URGENT: SAFETY NOTICE

Diphoterine® and Hexafluorine® Portable Autonomous Showers

- Inspection/modification of products by the user
- Specific instructions for use

Prevor ref.: NC 23850

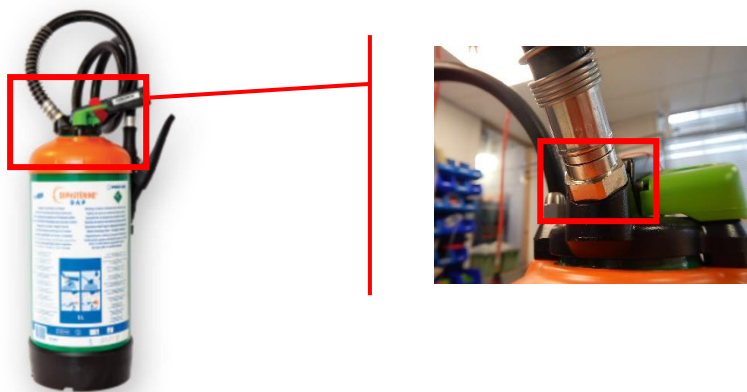
The defect is located at the level of the hose's attachment (following photo) at the head of the DAP.

Two similar incidents were reported to us indicating that **the hose had come off** at the nut holding it in connection with the DAP head.

The defect having been identified, we were able to develop a safety collar that fits over the nut. Thanks to a simple and resistant fixing system, this collar will prevent any risk of the hose coming off.

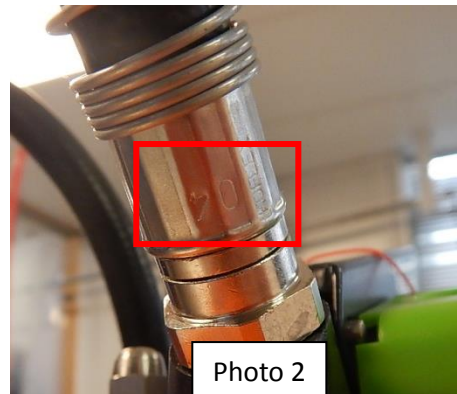
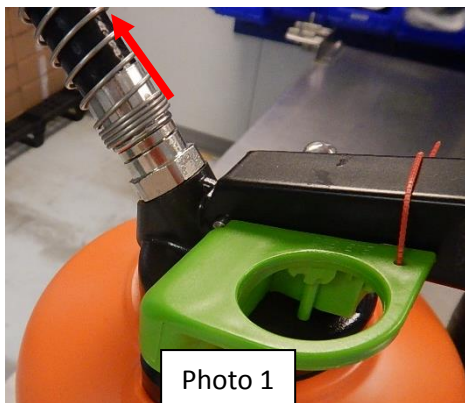
The DAP remains functional and solution will continue to flow through the DAP port. However, the application of the solution will not be as easy. We recommend lifting the device to keep the solution flowing over the person affected by a chemical splash, as shown in the photo below. The solution stream can be directed using a finger to direct the flow.

To read the batch number of the hose: lift the spring (photo 1) and read the 4 digits engraved on the metal part (photo 2).
